MODEL: DSC-W830**No. E58409319****Subject: Compatibility information between SY board
and MM flex board****Date:** Aug. 08. 2014**Symptom:**

OLD SY board (PCB suffix -11)

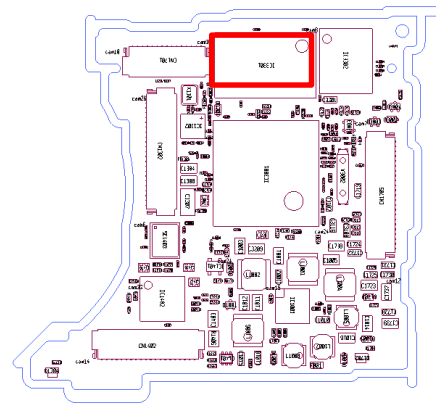
Because of design change, it is impossible to assemble revised SY board and previous MM flex board, also revised MM flex board and previous SY board.

SY board layout changed and MM flex board connector position shifted because IC is discontinued.

In case you replace SY board or MM flex board, see below matrix and choose suitable pair of parts.

MM-1002 flex board	MM-1008 flex board
SY-1035 board (-11)	Available	Not Available
SY-1035 board (-21)	Not Available	Available
